Oceana Gold (New Zealand) Limited
P O Box 5442
Moray Place
DUNEDIN 9058

RE: MACRAES PHASE 111 PROJECT-SECTION 92 REQUEST

Please find below our response to Questions 9a and 13a and to relevant sections of Questions 17 to 22.

Method: Spencer
Horz Seismic Load: 0.72
Factor of Safety: 0.53

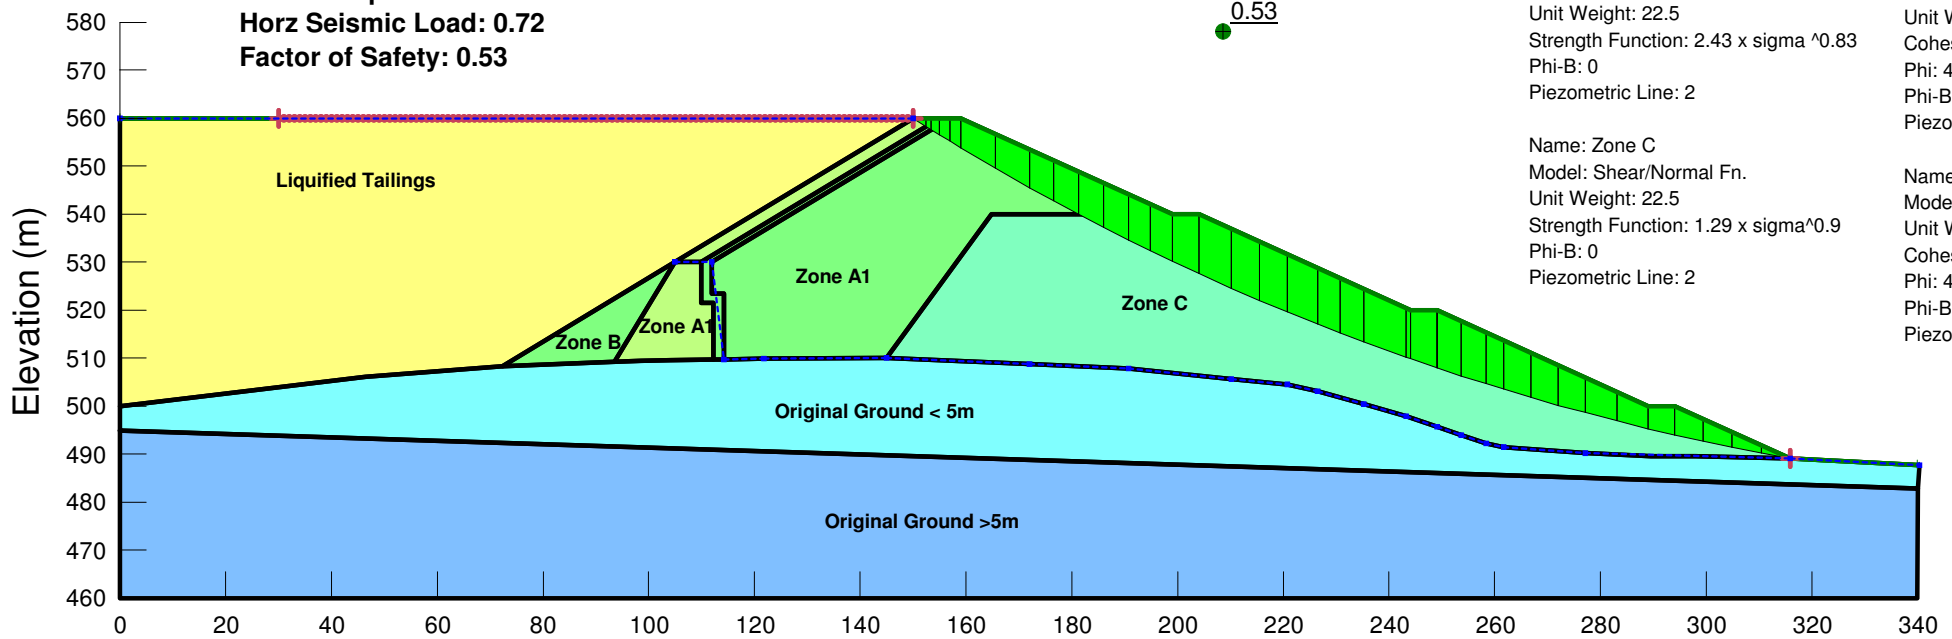
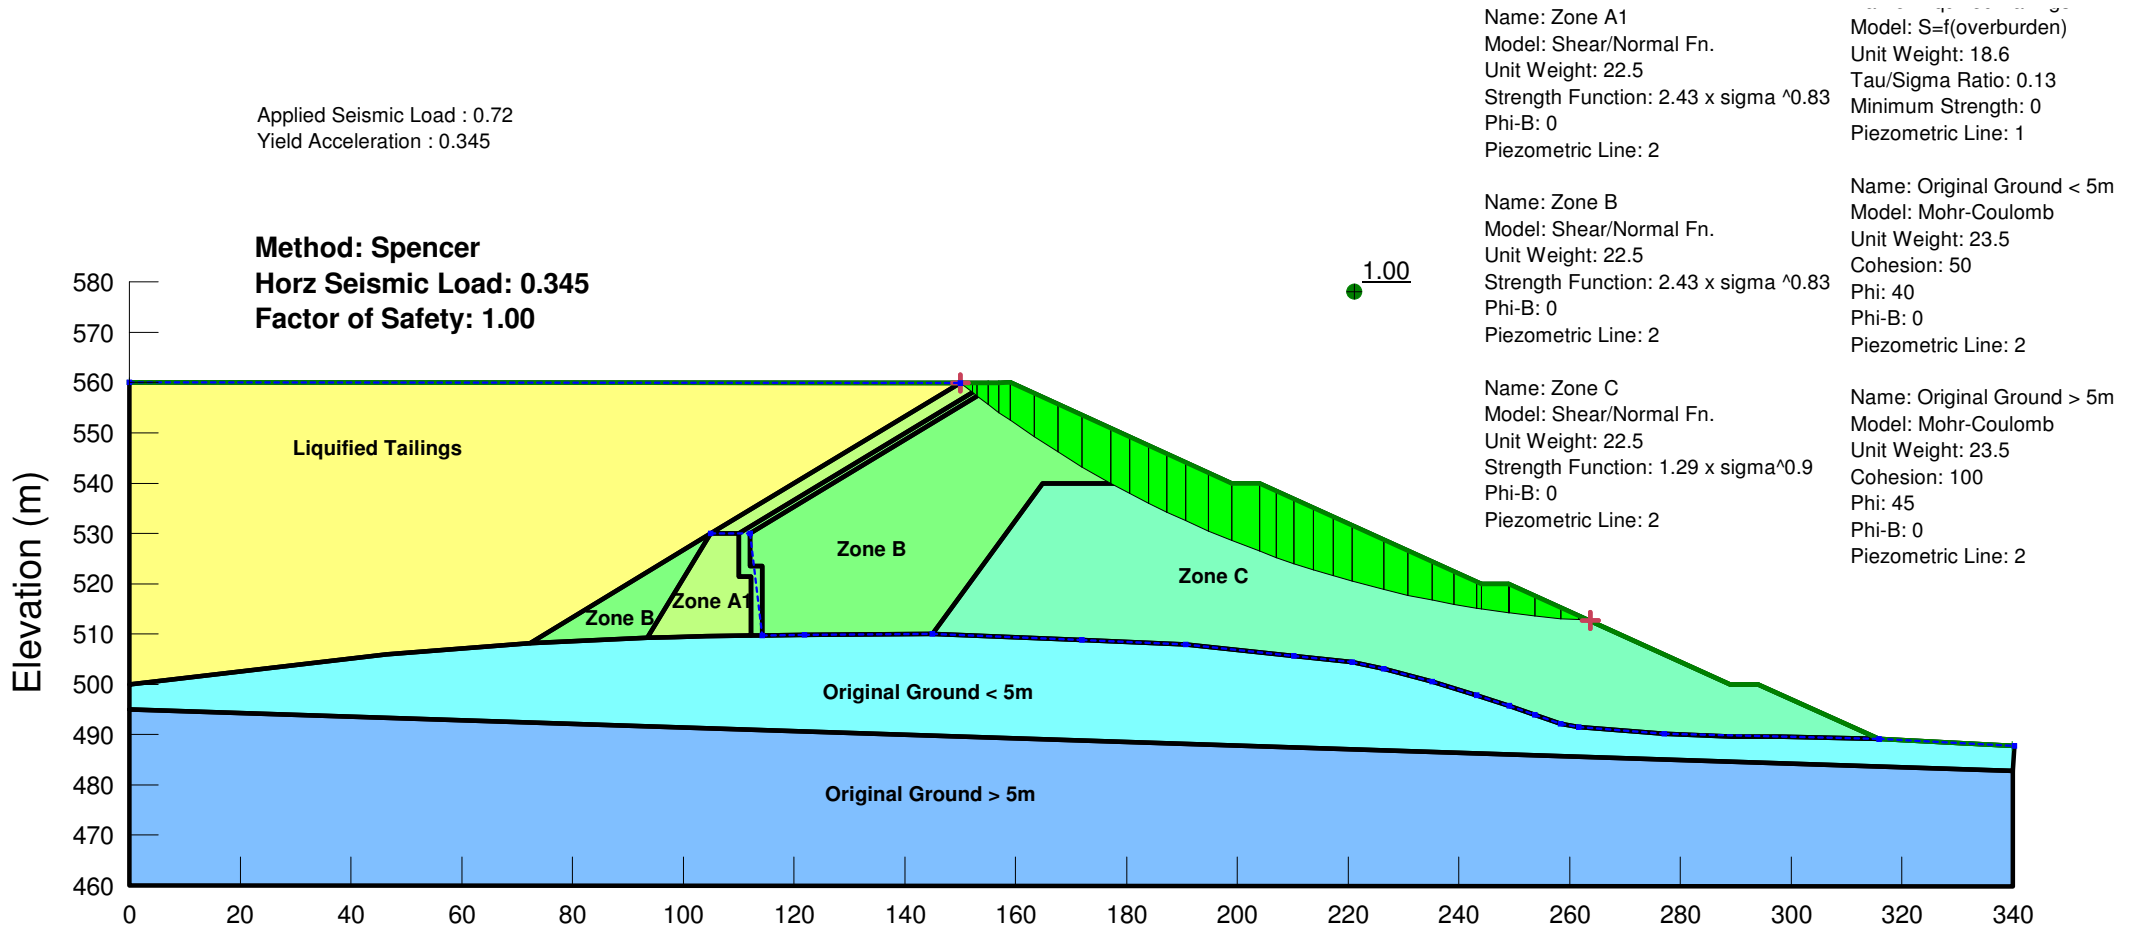
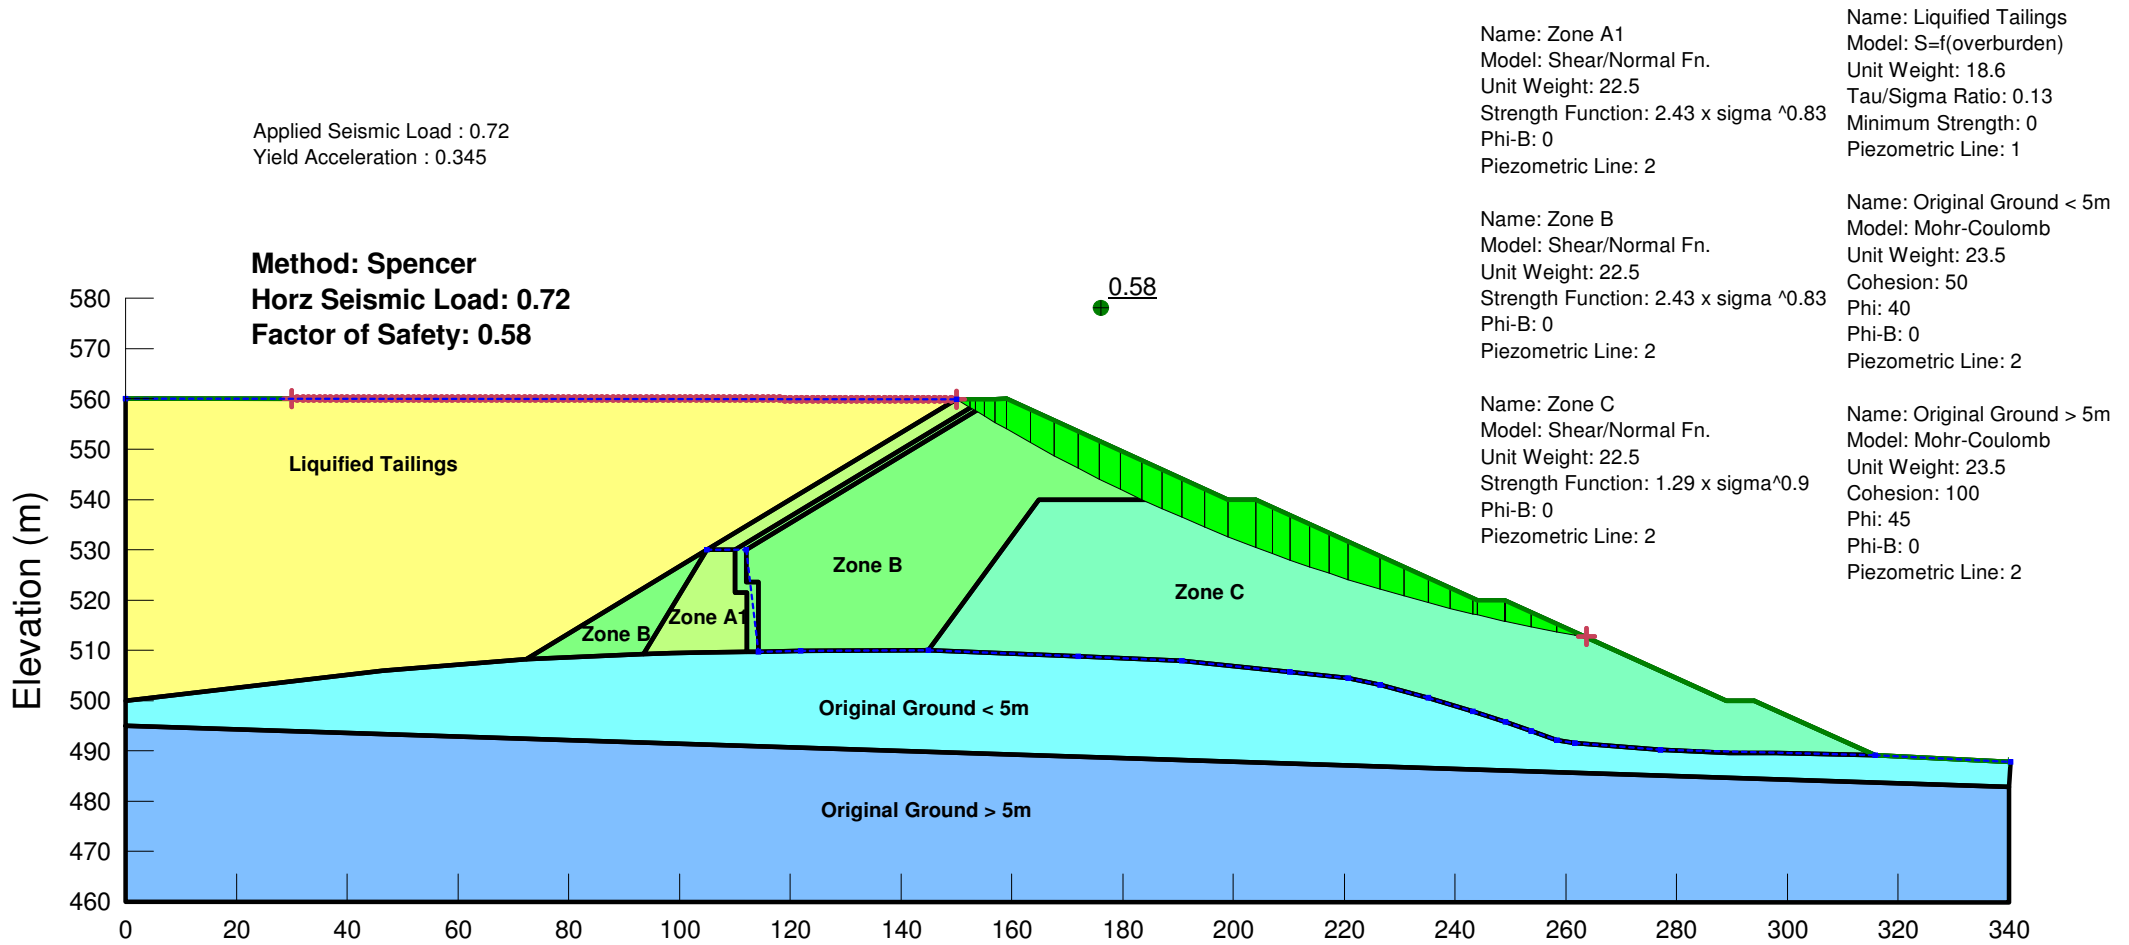
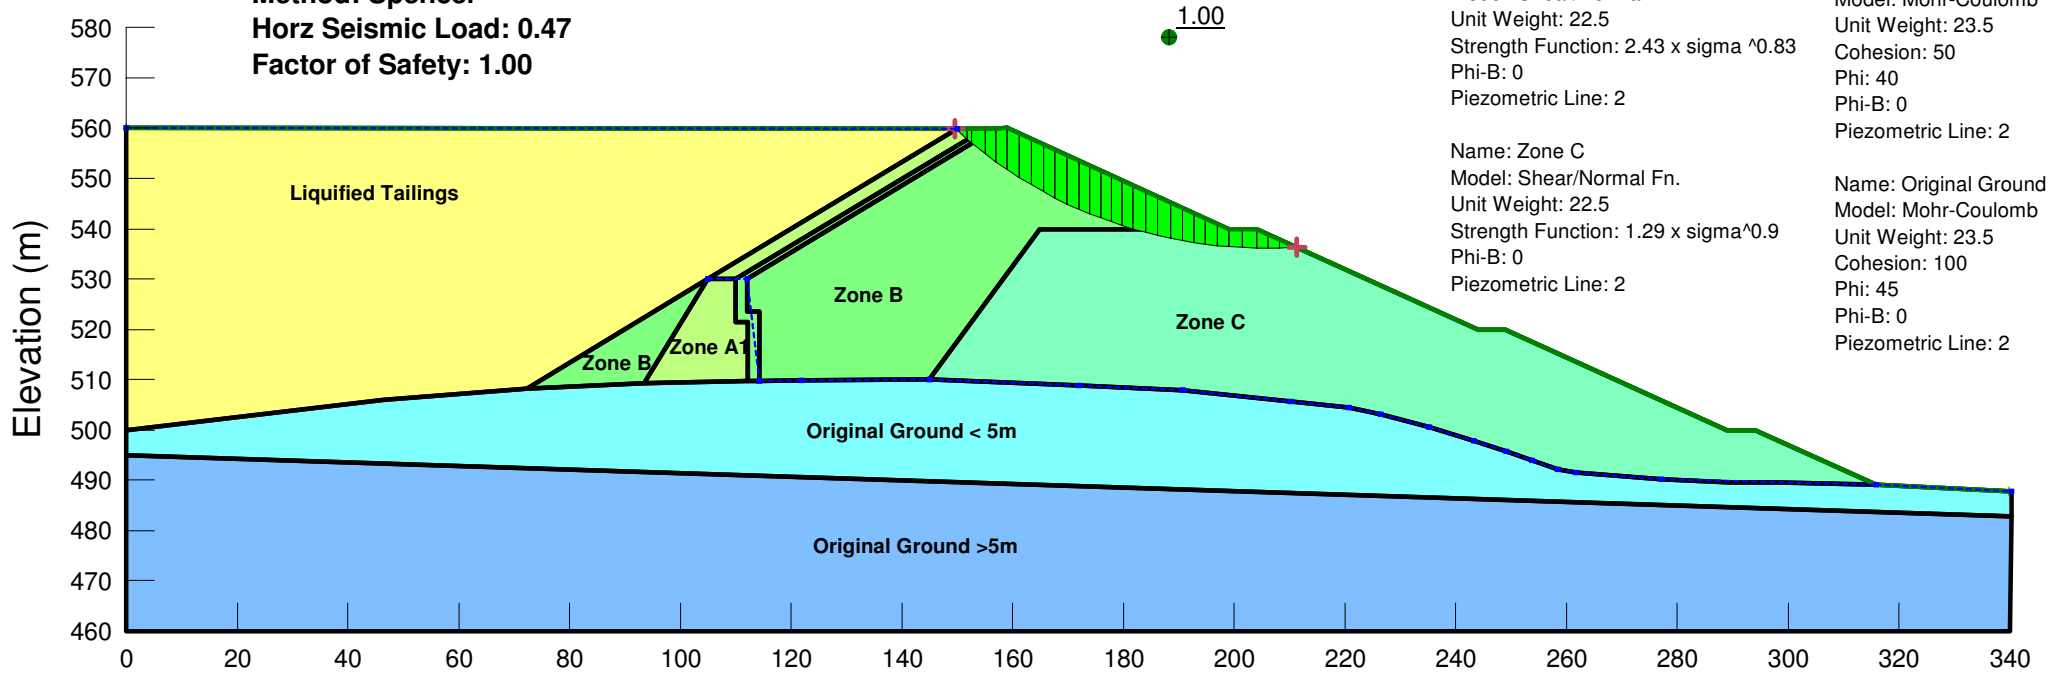
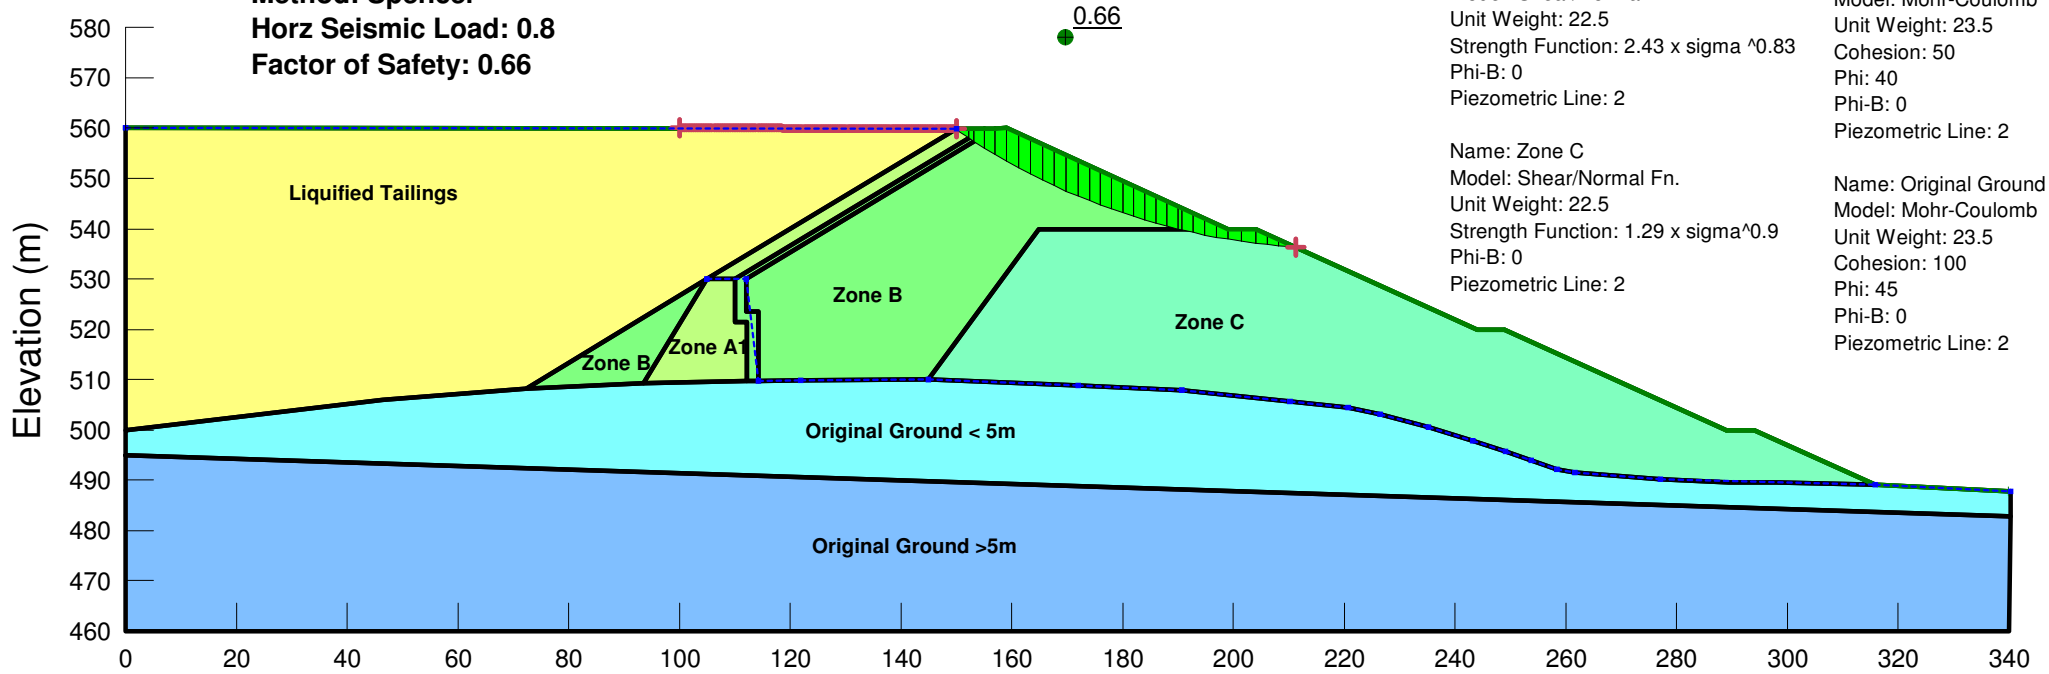
Q17.d) Figures D7 – D12 (appended to the report) show both yield accelerations and design loadings on the same figures. Please clarify the assessed yield accelerations and how these compare with the design earthquake loadings (i.e. OBE & MDE).

Figures D7 - D12 show the yield accelerations for critical circles (i.e. $F = 1.0$). The yield acceleration is equal to the 'Horiz Seismic Load' shown in the figures. The yield acceleration corresponds to the seismic horizontal load when FOS = 1.0. The actual design loadings and yield accelerations, where the FOS is less than 1.0, are summarised in Table D3 of Appendix 3 of the TTTSF Technical Report (Appendix 20 of the application). We note that Table D3 provided in the report has some errors. A correct version is shown below. There is no change to Figures D1 – D6. However we have made some amendments to Figures D7 – D12, specifically to include the design seismic load and the yield acceleration on the Figures and new versions of these Figures are appended. Figure D9 has no yield acceleration because the slope will not yield under the design seismic load. We also include an additional five figures (Figures D7a, D8a, D10a, D11a, D12a) to show the analysis of the embankment under the design seismic load. The FOS is generally less than 1.0 indicating yield and that permanent deformations can be expected.

Loading	kh (g)(1)	kc (g)(2)	Predicted Permanent Deformation (3) (cm)		Depth of Failure Surface	Figure No.
			u50	u5		
475 year	0.33	0.31	0.01	0.02	H	D7
475 year	0.36	0.34	0.00	0.01	$\frac{2}{3}H$	D8
475 year	0.36	-	-	-	$\frac{1}{3}H$	D9
MDE	0.72	0.31	1.7	14	H	D10
MDE	0.72	0.34	1.2	9.5	$\frac{2}{3}H$	D11
MDE	0.8	0.47	0.5	4.1	$\frac{1}{3}H$	D12
